MFN 06-189

Subject: Response to Portion of RAI Letter Number 20 Related to ESBWR Design Certification Application – Seismic Design – RAI Numbers 2.5-1, 3.7-5, 3.7-7, 3.7-8, 3.7-11, 3.7-12, 3.7-25, 3.7-26, 3.7-29, 3.7-34, 3.7-52, and 3.7-55

**Response to Portion of NRC RAI Letter No. 20
Related to ESBWR Design Certification Application
Seismic Design**

**RAI Numbers 2.5-1, 3.7-5, 3.7-7, 3.7-8, 3.7-11, 3.7-12, 3.7-25, 3.7-26,
3.7-29, 3.7-34, 3.7-52, and 3.7-55**

Figure 3.7-7 (1) - Horizontal “outcrop” ground motion spectra for the SSE, CB, RB/FB, and two deeper horizons.

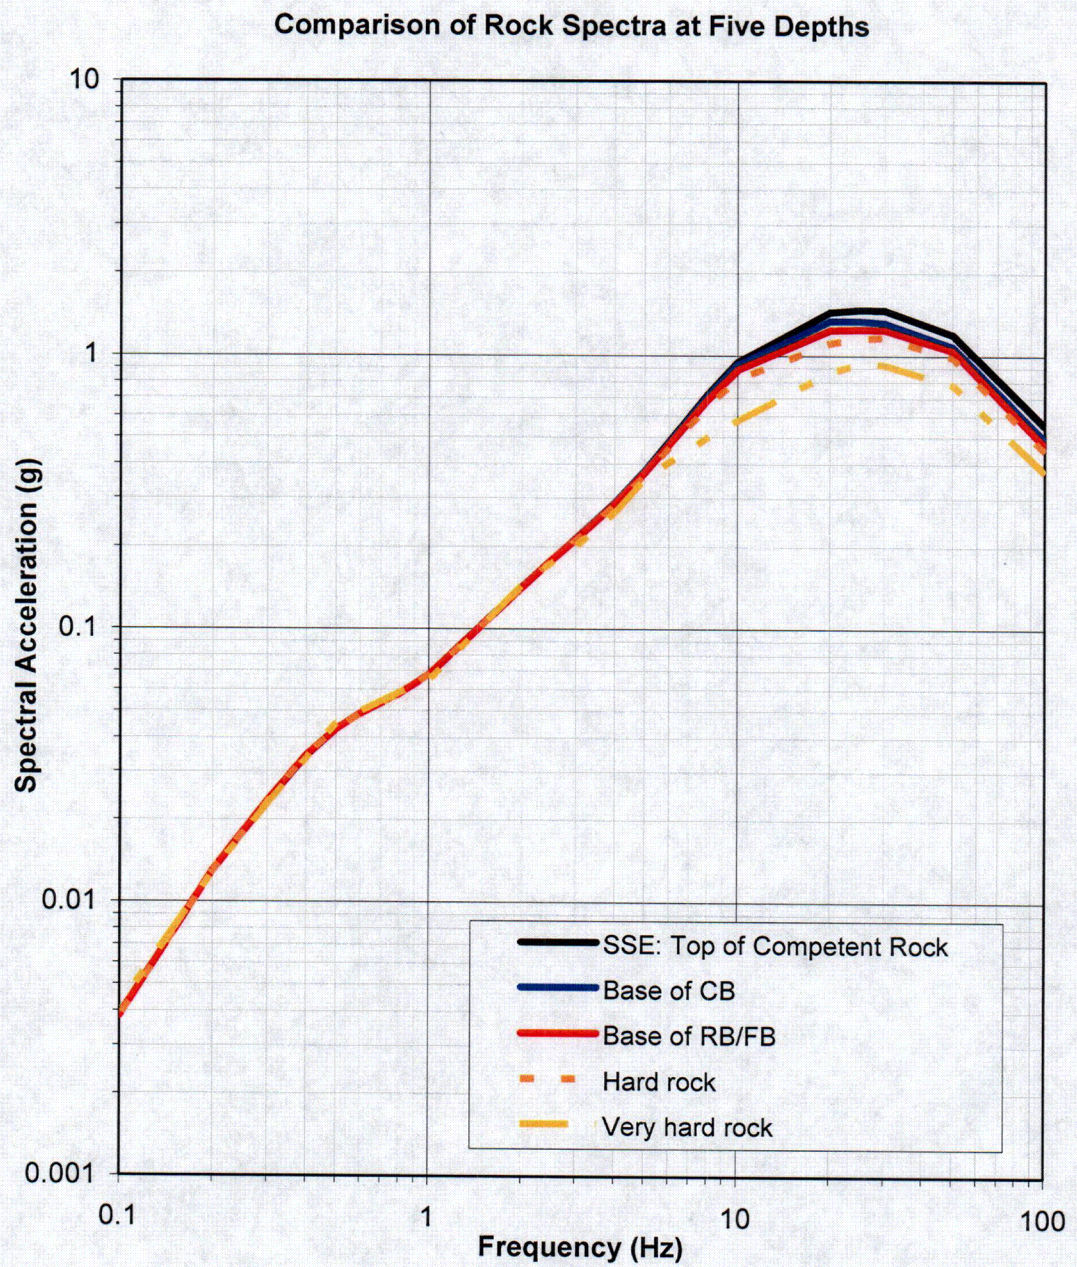
In DCD Section 3.7.1, the applicant stated that because the Clinton and Grand Gulf site conditions are bounded by the envelope of the generic site and North Anna site conditions, the North Anna ESP site is selected for further consideration in conjunction with generic sites for site enveloping seismic design of the ESBWR standard plant. In addition to the ground motion response spectra, and time histories provided in the DCD, the applicant is requested to include in the DCD a detailed description of the North Anna site conditions (e.g., geotechnical properties), including response spectra at various depths through the profile consistent with design spectra.

The horizontal North Anna Early Site Permit Safe Shutdown Earthquake spectrum is defined at the top of competent rock horizon and is shown in Figure 2.5-55A of the ESP SSAR. The horizontal target spectra for the ESBWR control building and reactor/fuel building are shown as solid light gray lines in DCD Figures 3.7-24, 3.7-26, 3.7-30, and 3.7-32. These spectra and spectra for the deeper horizons of Table 3.7-7 (2) are all shown in Figure 3.7-1 (1). All spectra are for "outcrop" motions at the free ground surface.

The spectra of Figure 3.7-7 (1) are the envelopes of high and low frequency target spectra used to define outcrop ground motions at horizons within the site rock profile. Figure 3.7-11 (1) reproduces the CB and RB/FB spectra of Figure 3.7-7 (1) and adds RG 1.60 anchored to a PGA of 0.3g. Comparison of this figure with DCD Figure 2.5-1 implies that the high frequency target spectra (shown in DCD Figure 2.5-1) control motions for frequencies above about 2 Hz, and that the low frequency target spectra (enveloped by the low frequency part of the spectra in Figure 3.7-7 (1) above) control motions for lower frequencies. It is apparent that the RG 1.60 spectrum envelopes by a factor of over 5 the low frequency part of the site-specific ground motion spectra for all evaluated North Anna Early Site Permit horizons (including the CB and RB/FB base horizons).

Figure 3.7-11 (1) - Comparison of North Anna ground motion spectra at the CB and RB/FB (and other) horizons with a RG 1.60 spectrum anchored to 0.3g PGA.

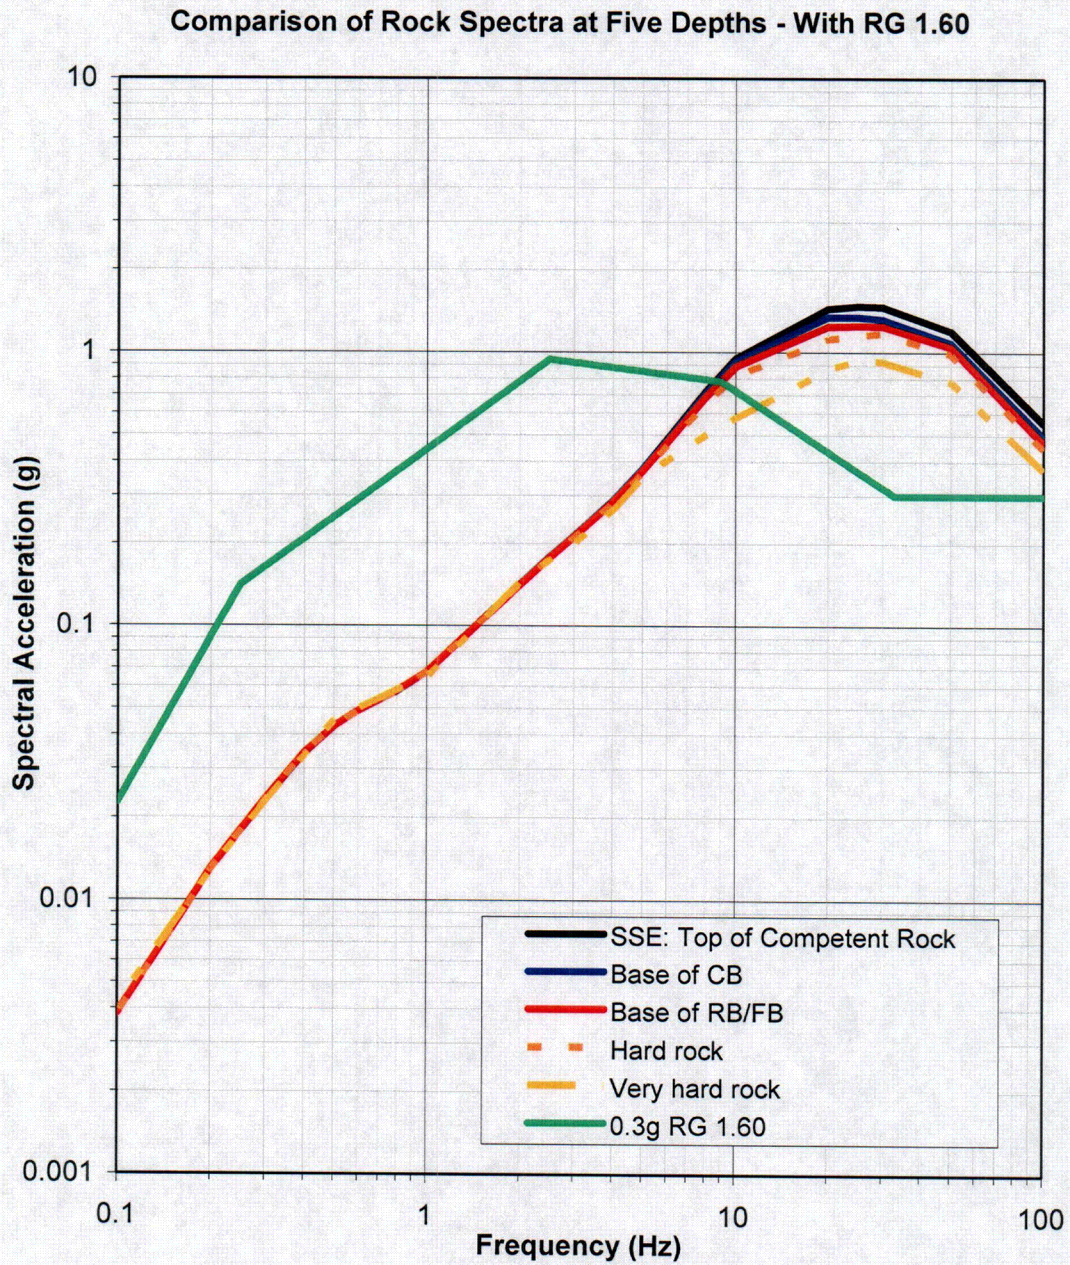
In the fourth sentence of the first paragraph of DCD Section 3.7.1.1.3 (Page 3.7-4), the applicant stated that, since the low frequency part of North Anna SSE ground response spectra are enveloped by the 0.3g RG 1.60 generic site response spectra with large margins, only the high frequency part needs to be explicitly taken into account. The staff requests the applicant to provide justifications for the conclusion drawn in the DCD and a comparison plot of these two sets of ground response spectra in Tier 2 DCD Section 3.7.1, "Seismic Design Parameters."

Figure 3.7-25 (1) - Crane Location for Seismic Analysis

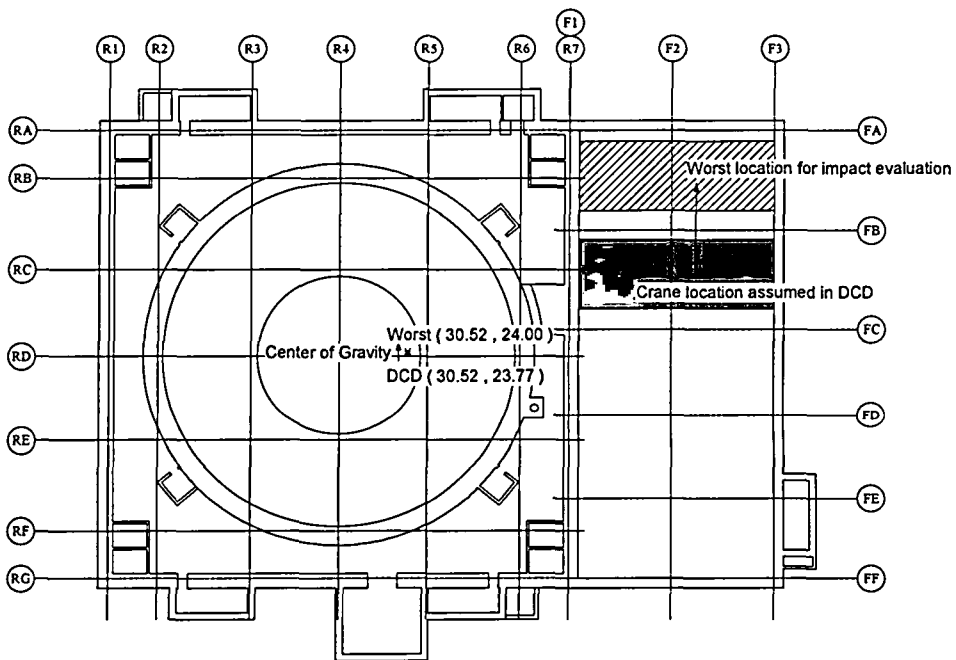
For the development of the RB/FB seismic model, the staff requests the applicant to specify in the DCD where the heavy crane (with trolley) is to be parked during plant operation. This information is needed to properly locate the mass and assess the effects of mass eccentricity in the seismic analysis. This information also needs to be identified as an interface item for the COL applicant.

For the development of the RB/FB seismic model, the heavy crane (with trolley) is assumed to be parked between col-rows R3 and R4 in the RB and between col-rows FB and FC in the FB.

In order to assess the effects of crane location in the seismic analysis, the change of mass eccentricity was calculated varying the crane locations. A worst location is considered in the sensitivity analysis. Figure 3.7-25(1) shows the changes of the centers of gravity at the RB and FB crane floors. The centers of gravity moved only 25 cm maximum. Table 3.7-25 (1) shows comparison of eigenvalue analysis results for RBFB model in Fixed-base case. It is found that the difference of frequencies due to the crane location is negligibly small.

Hence, there is no need to identify crane location as an interface item for the COL applicant.

Figure 5.1-1. ESBWR Horizontal SSE Design Ground Spectra at Foundation Level

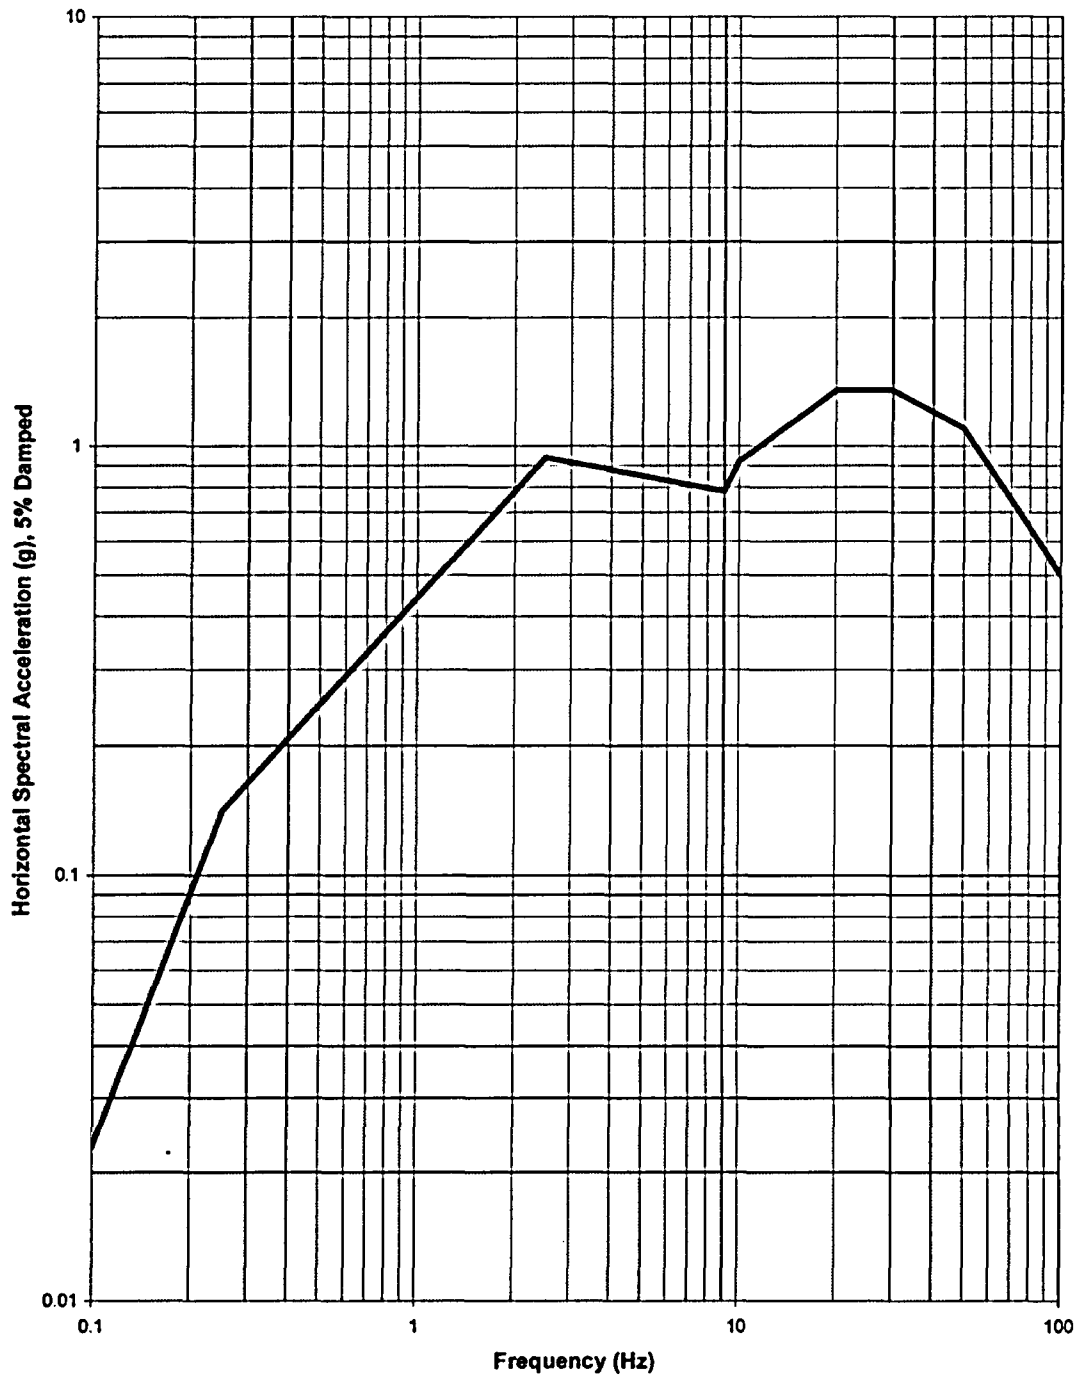
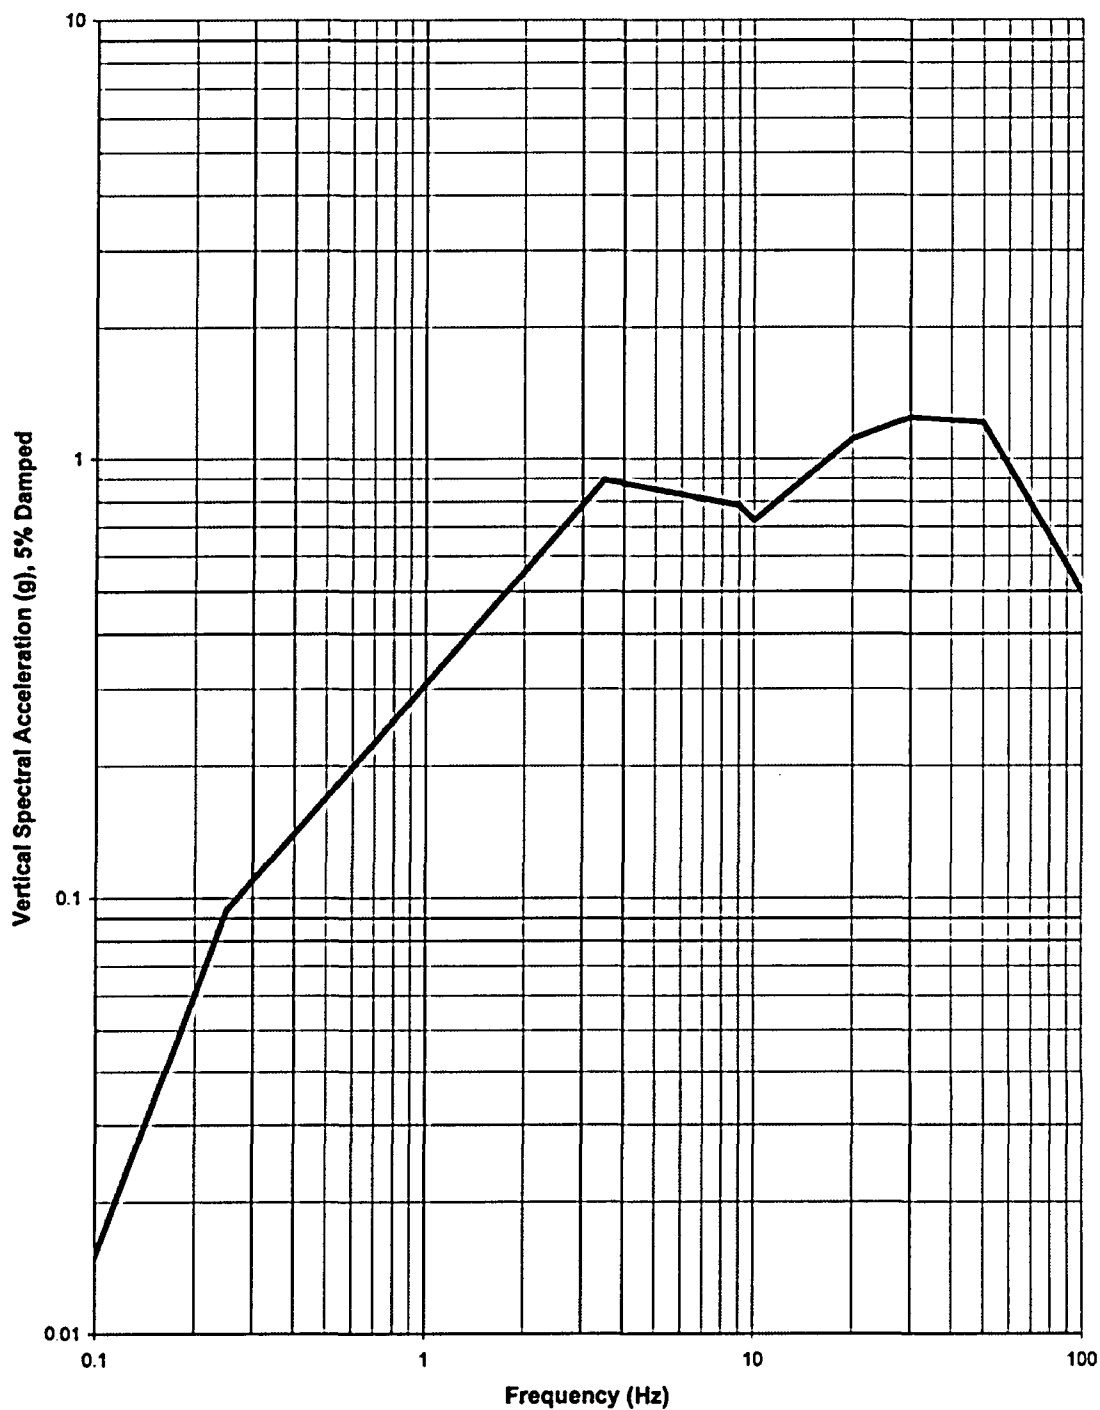
In DCD Section 3.7.1, the applicant stated that seismic design parameters (including seismic ground motion response spectra) considered for the ESBWR seismic design comprise two site conditions, generic and North Anna early site permit (ESP) sites. It is not clear from the descriptions provided in DCD Section 3.7.1 if the intent of the DCD is to show that (a) the design is appropriate for the North Anna site and any other generic site for which the RG 1.60 response spectrum is the appropriate SSE; or (b) if the design is to be considered appropriate for any site whose design response spectrum falls below the envelope of the RG 1.60 and North Anna design spectrum. The applicant also stated on Page 3.7-1, that the SSE is based upon an evaluation of the maximum seismic potential at a site. The DCD indicates that the results from the two separate ground motion sets are considered in the plant evaluations and development of enveloped responses. If the envelope spectrum were to be specified as the SSE, then a single set of time histories appropriate for this envelope spectrum would be used to generate enveloped responses. The staff requests the applicant clarify the definition of the SSE being used for the plant design, and also justify that the enveloped responses from load cases using multiple time histories (generic and North Anna) in fact leads to a conservative result of responses that would be obtained from a single ground motion time history (envelope of generic and North Anna ESP sites).

DCD Tier 2 Table 2.0-1, Section 2.5.2, Figure 2.5-1, Figure 2.5-2, and Section 3.7.5.1(1) will be revised in the next update as noted in the attached markups. Similar changes will be made to DCD Tier 1 Table 5.1-1, Figure 5.1-1 and Figure 5.1-2 in the next update as noted in the attached markups.
